24 September 2019

TRACEWAY PARK SOFTBALL CONCESSION STAND
200 Soccer Row
Clinton, MS 39056

ADDENDUM NO. 02

SHEET A104 "REFLECTED CEILING PLANS"

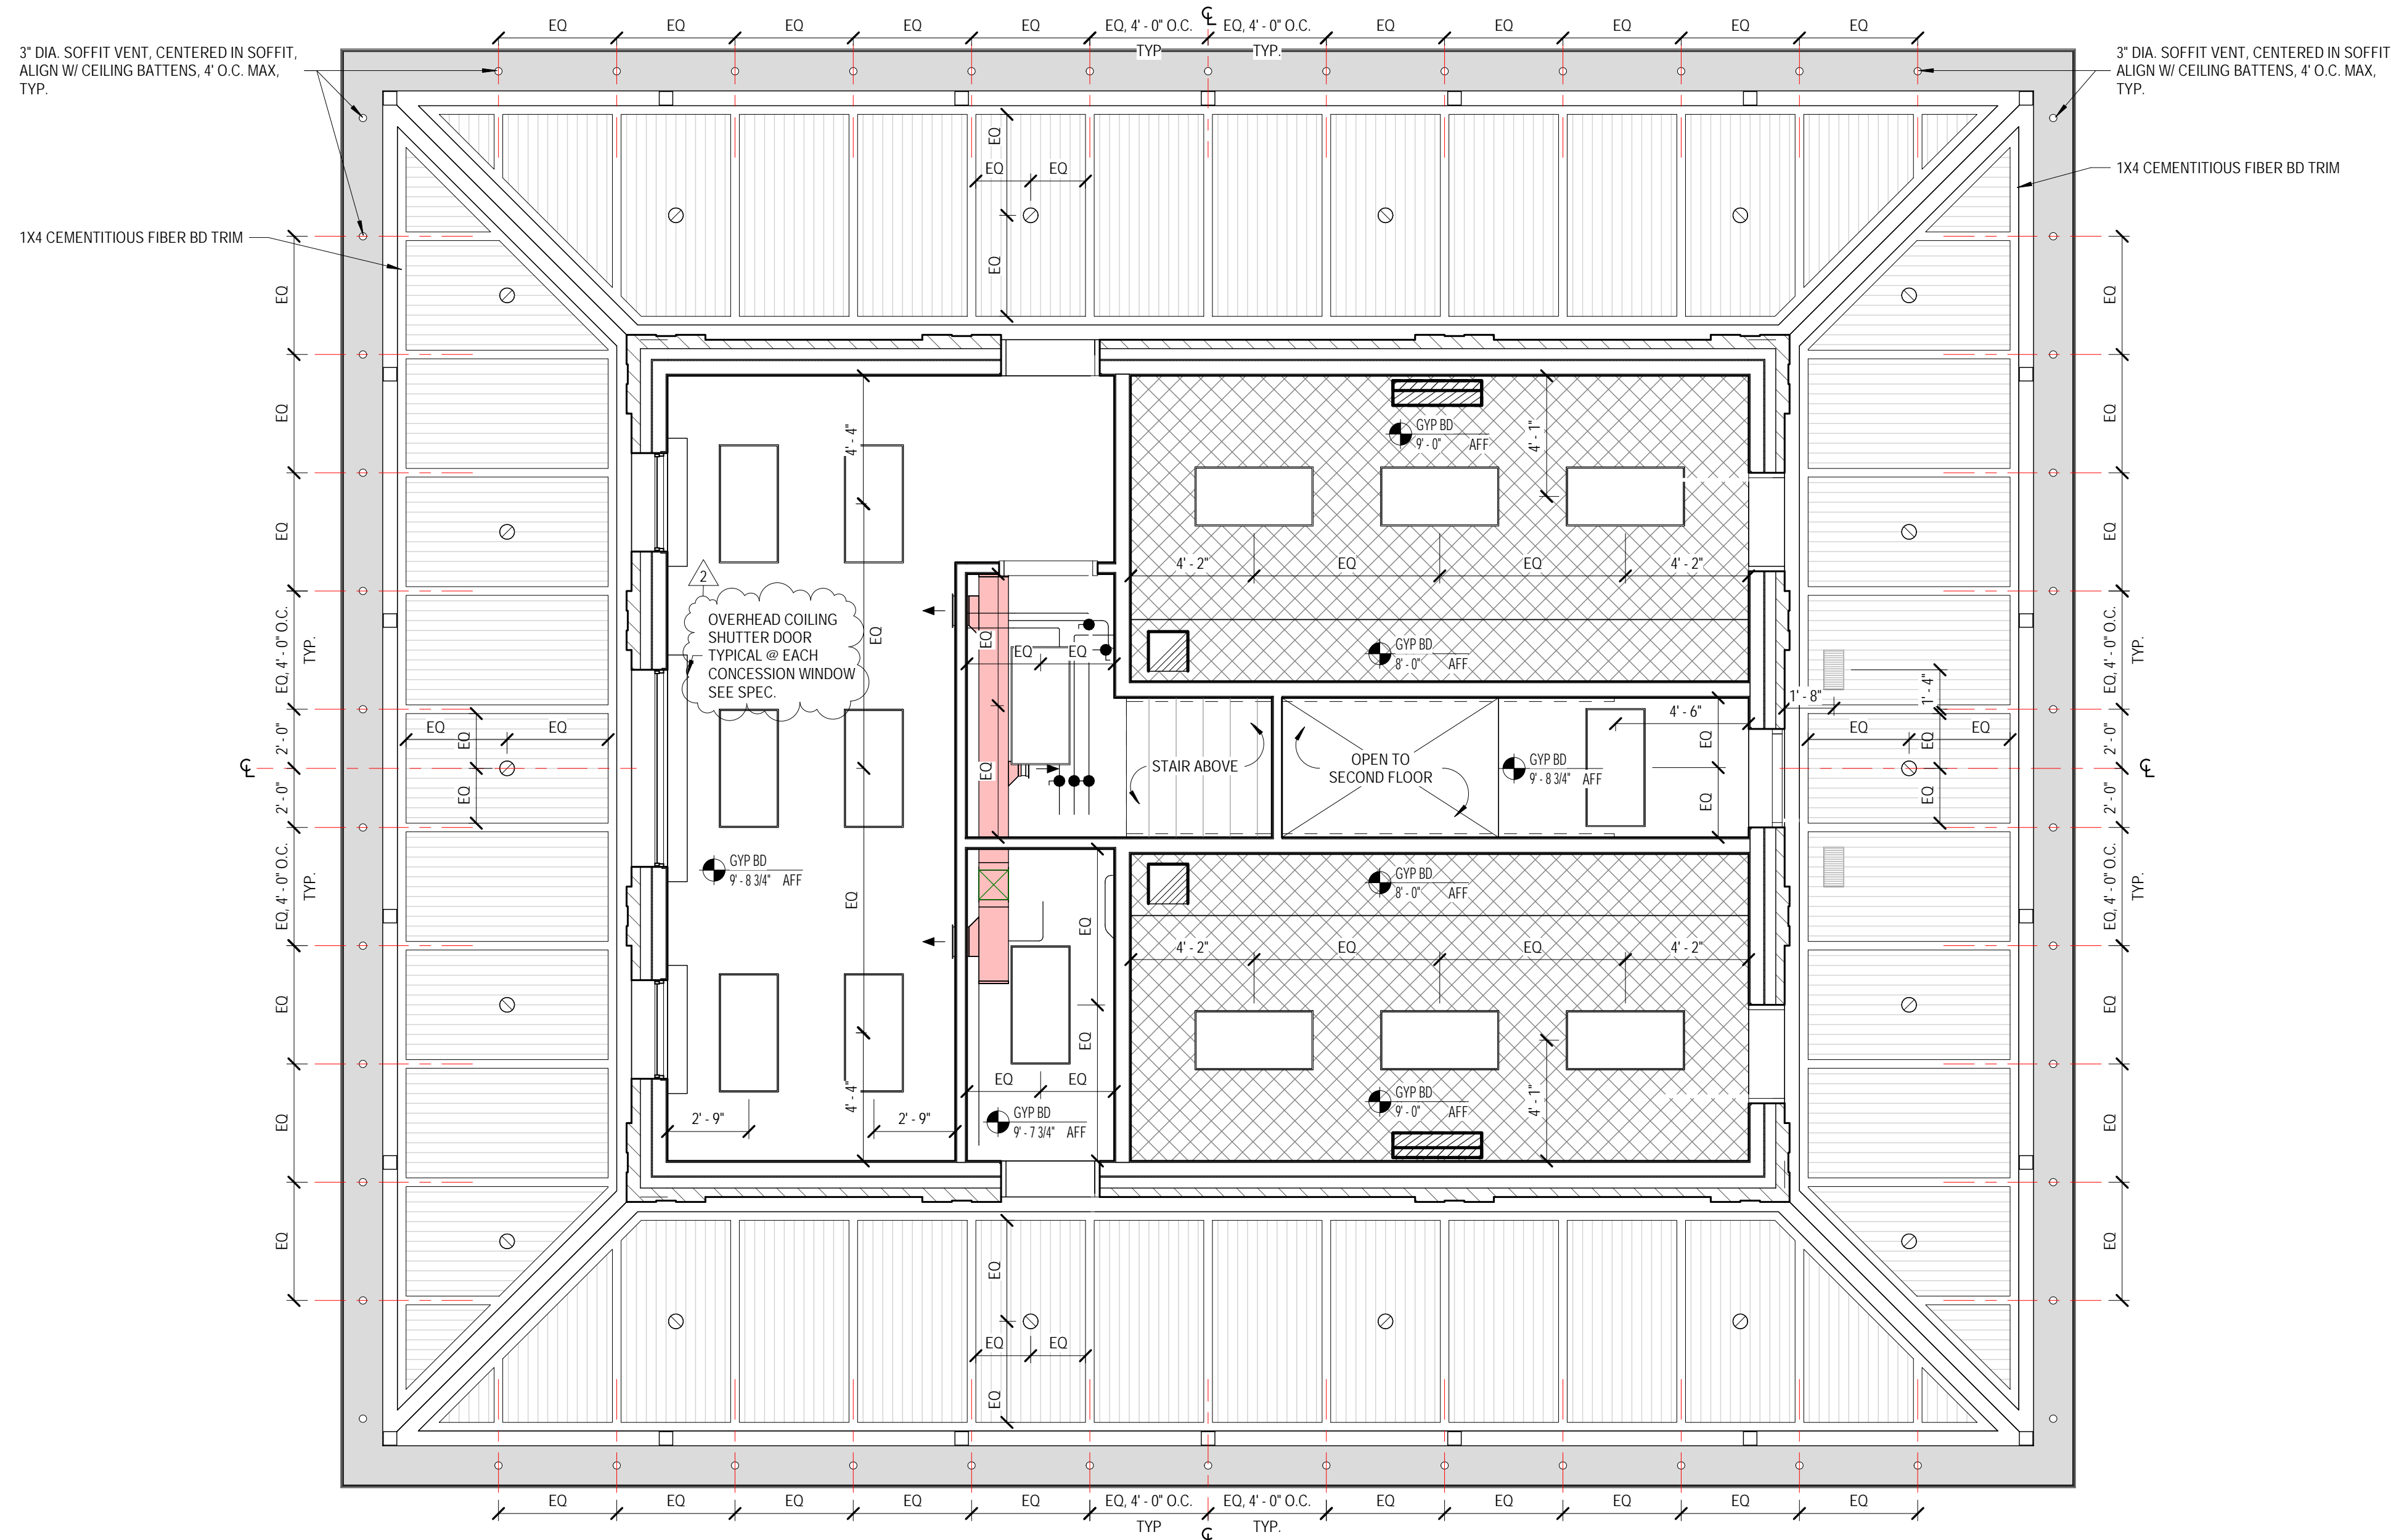
ADD note referencing the overhead coiling shutter doors at each concession window. Overhead coiling shutter doors shall be lockable.
